CITY OF NORMAN, OK HISTORIC DISTRICT COMMISSION MEETING - RESCHEDULED FROM 4/1/24

Municipal Building, Council Chambers, 201 West Gray, Norman, OK 73069
Monday, April 08, 2024 at 5:30 PM

CITY OF NORMAN, OK STAFF REPORT

Commission Action: Consideration of approval, rejection, amendment, and/or postponement of (HD 23-41) Certificate of Appropriateness for the replacement of the garage door for the property located at 712 Miller Avenue.

SOUTH ELEVATION
 1/4" = 1'-0"

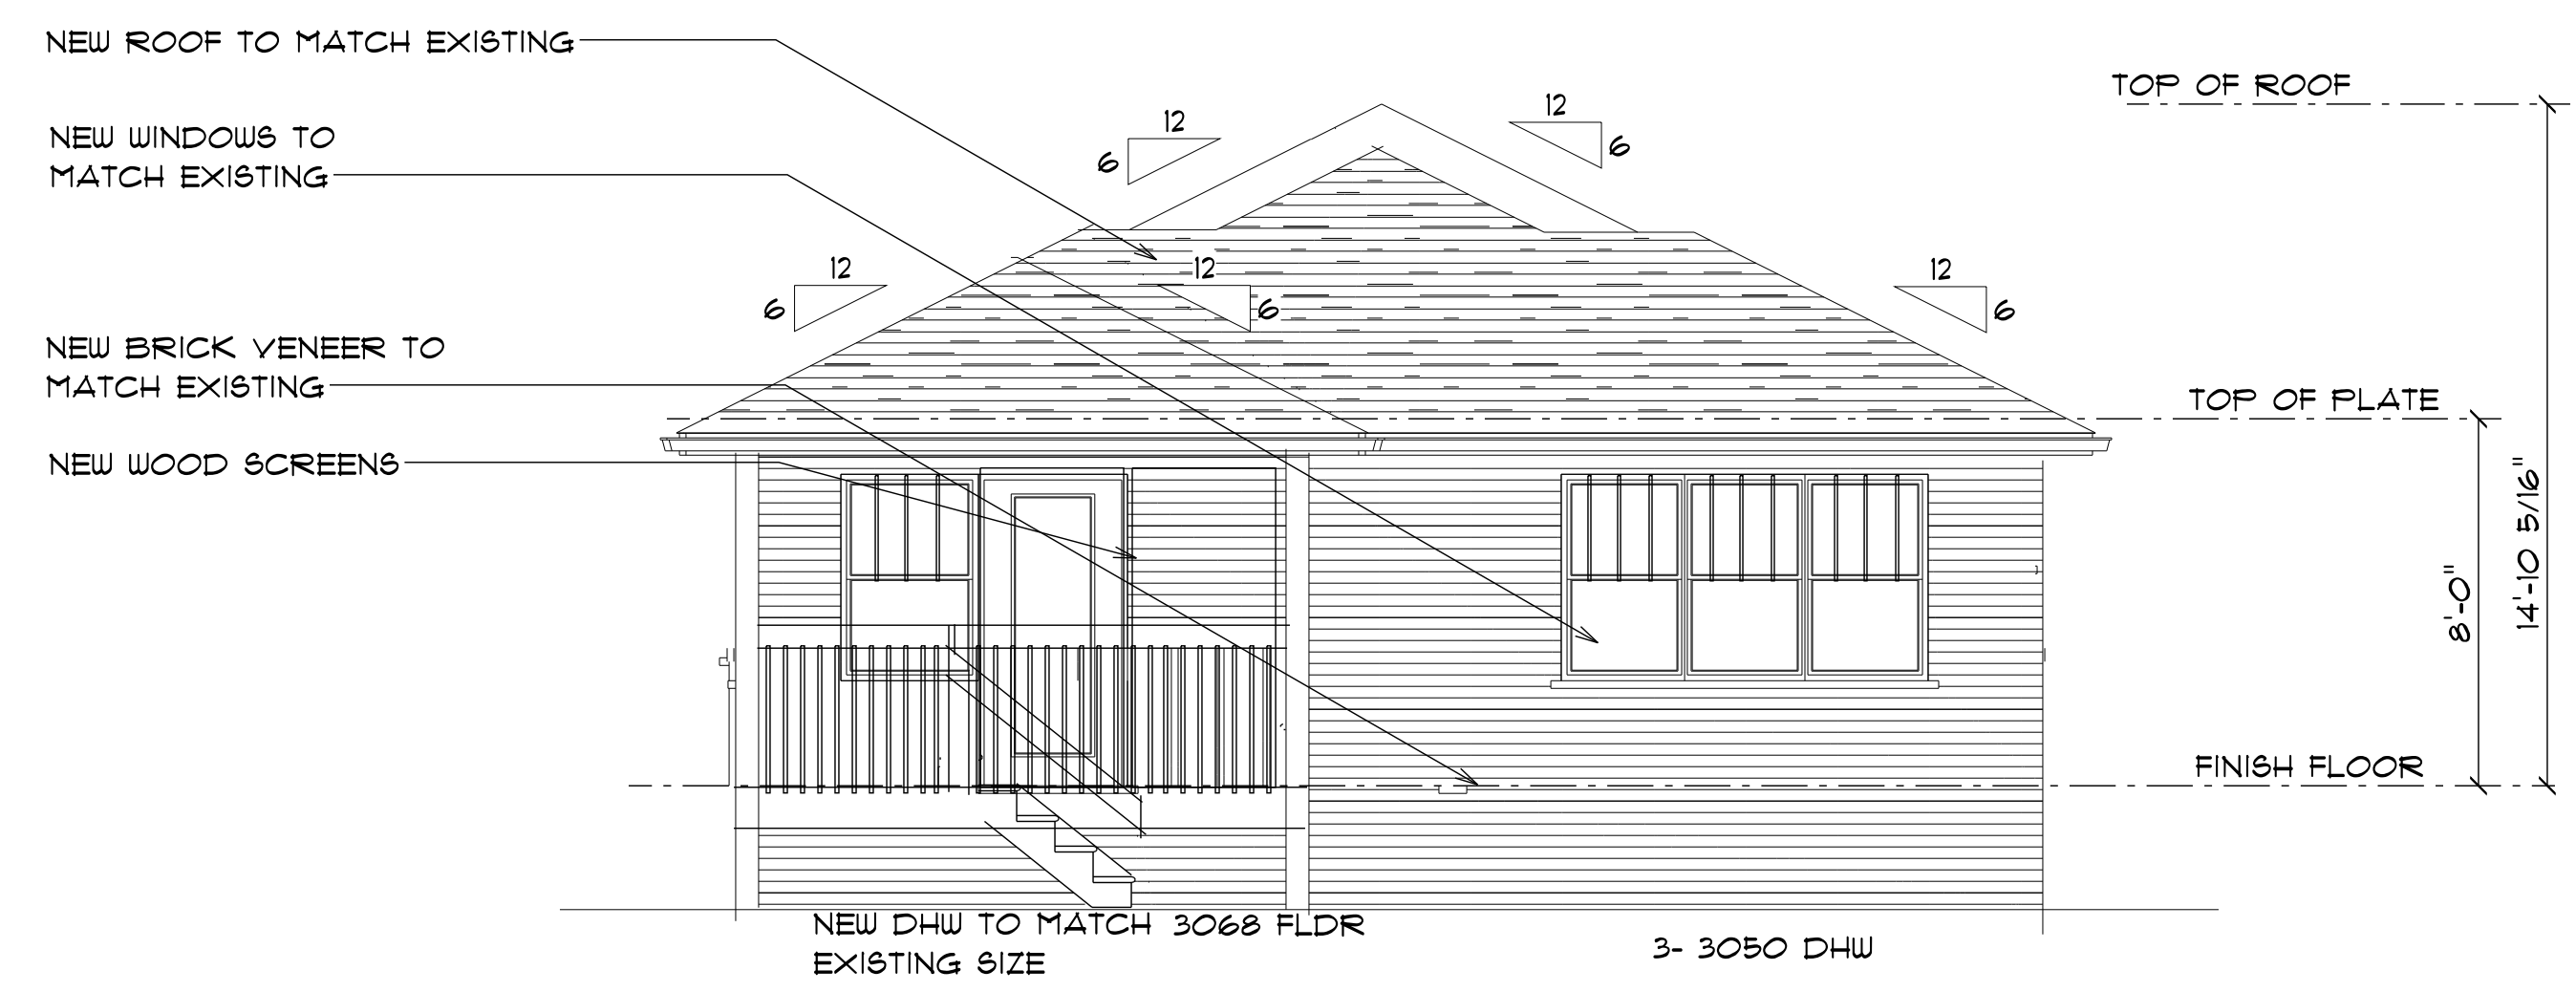
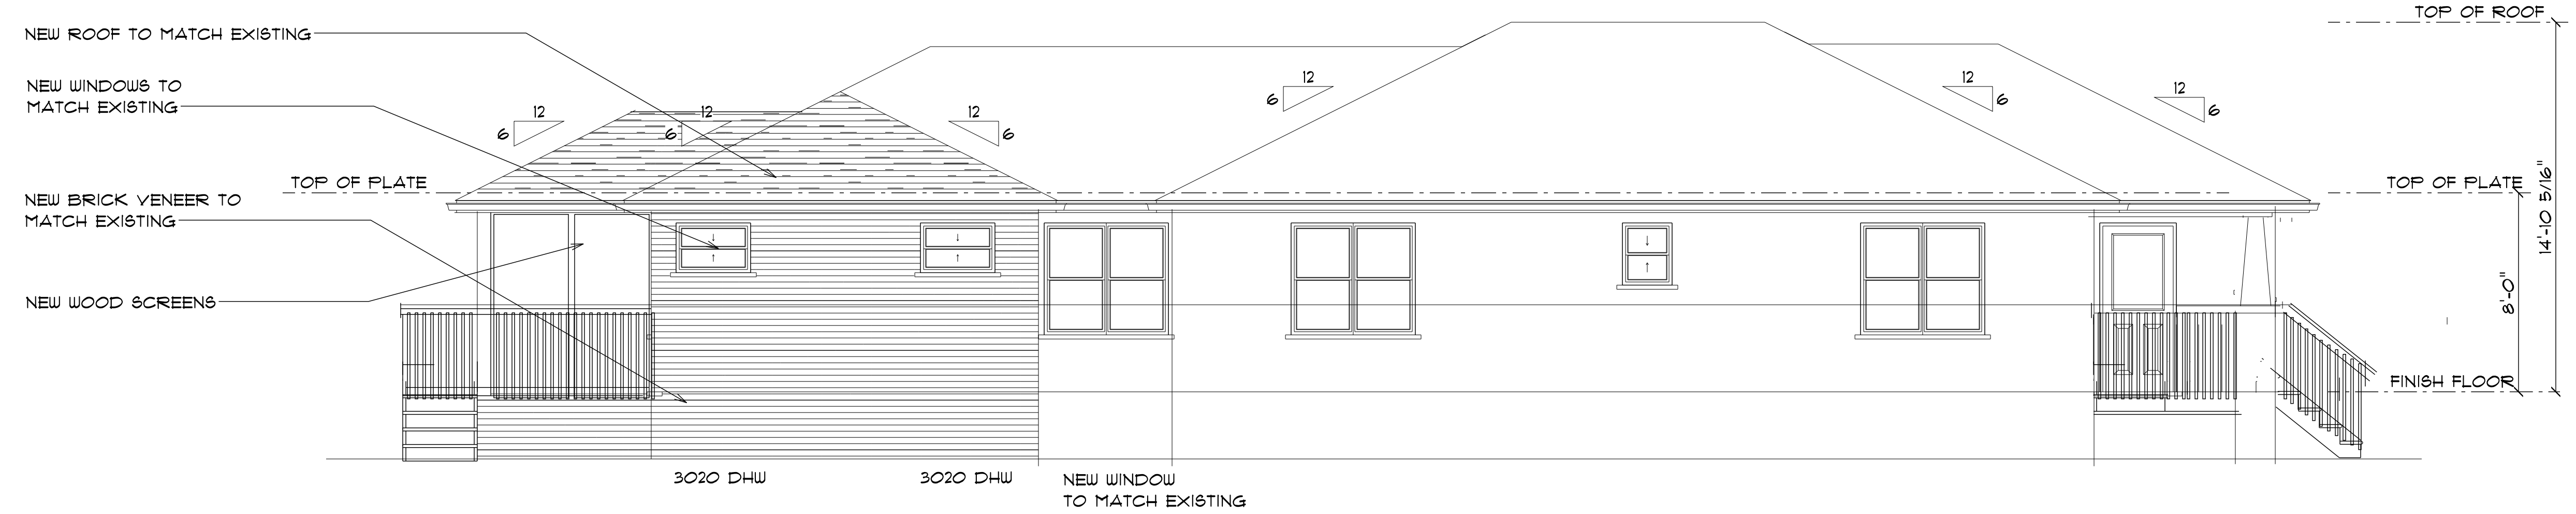
- Cameron Brewer made a presentation regarding an addition to the back of their house to add a primary suite as well as an office area.
- Mr. Brewer showed the Commission proposed site plan and drawings of proposed addition.
- Mr. Brewer stated that all exterior materials will match the house and will be wood.

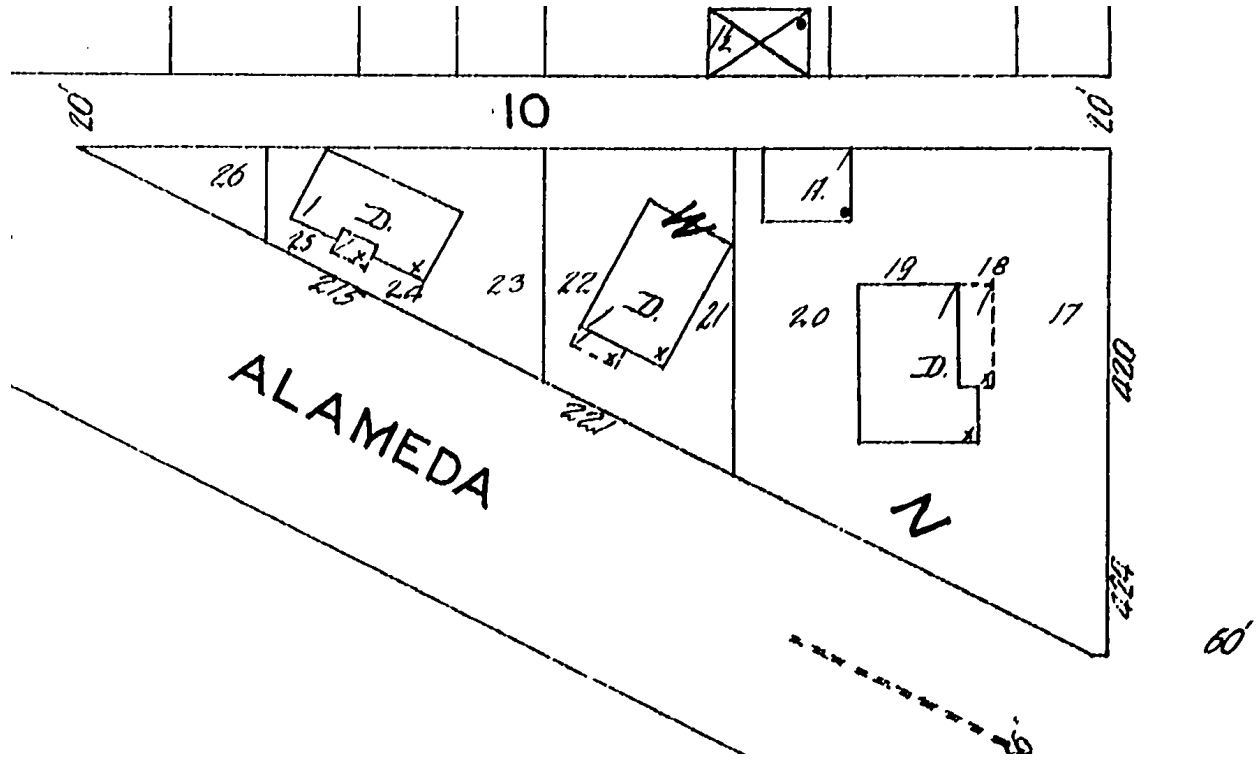
- 1) Replace French door at end of driveway with windows of similar size and age as the rest of the windows. Cedar shutters on front of house. Remove wrought iron from porch, build craftsmen tapered pillars, wooden railing.
- 2) Remove window that contains the window AC unit at the end of the driveway and replace with matching siding.
- 3) Lift the rear exterior door approximately 17" to meet the new height of the laundry room floor. Add steps per code. Add roof ridge caps.
- 4) Remove aluminum storm windows and replace with custom built wood storm windows that will match prime window measurements at the bottom rail, top rail, stiles, and meeting rails. Mounted with sash hanges and equipped with stays.
